PLEASE POST FOR 120 DAYS

On the fork models listed below, Answer Products has found that under extreme loads or in high stress situations that could be encountered while riding, some aluminum alloy steerer tubes can deform at the press fit into the crown. After becoming deformed, the steerer tube can then separate from the crown causing loss of control of the bicycle with risk of physical injury to the rider. Only aluminum alloy steerers that utilize carbon sleeves, only on the fork models listed below, are subject to this issue.

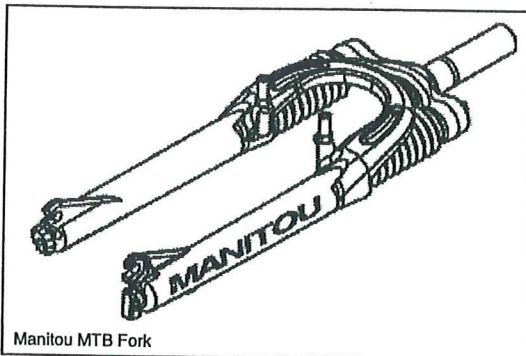
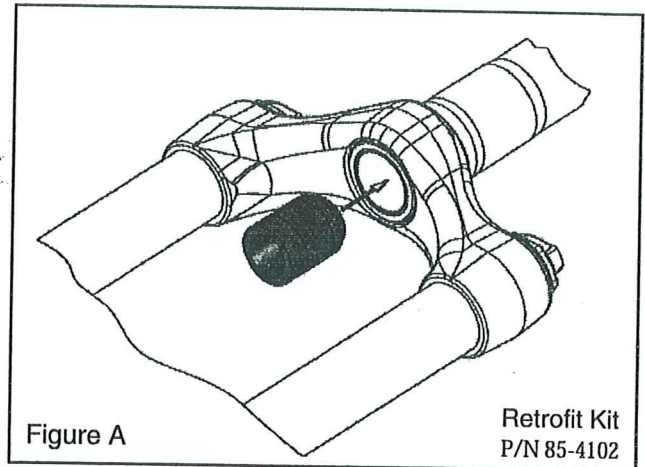
Therefore, we are requesting that the models listed below be retrofitted with an insert that reinforces this area of the steerer tube. (Figure A)

Answer Products is supplying these inserts free of charge to dealers and owners of these forks. Either visually inspect the underside of your own crown steerer (as shown in figure A) or have your authorized dealer inspect your crown steerer prior to your next ride.

If it does not have a red or silver aluminum insert present DO NOT CONTINUE TO USE THE BICYCLE until a reinforcing sleeve can be fitted to your fork. If the carbon sleeve appears to be cracked or damaged in any way, contact Answer Products, Inc. Warranty at (800)423-0273.

These free inserts come with instructions and can be easily installed by an individual or at a shop on the spot. NO disassembly of the bicycle or fork is required. The red or silver aluminum inserts *have been* installed on all production forks shipped from Answer *starting December 21, 1999, so these forks do not require updates* All of the models listed below produced prior to this time will need a red or silver aluminum insert installed to reinforce the steerer tube in the crown area. **For obtaining inserts or for further information, please contact your dealer or Answer Products at (800)423-0273.**
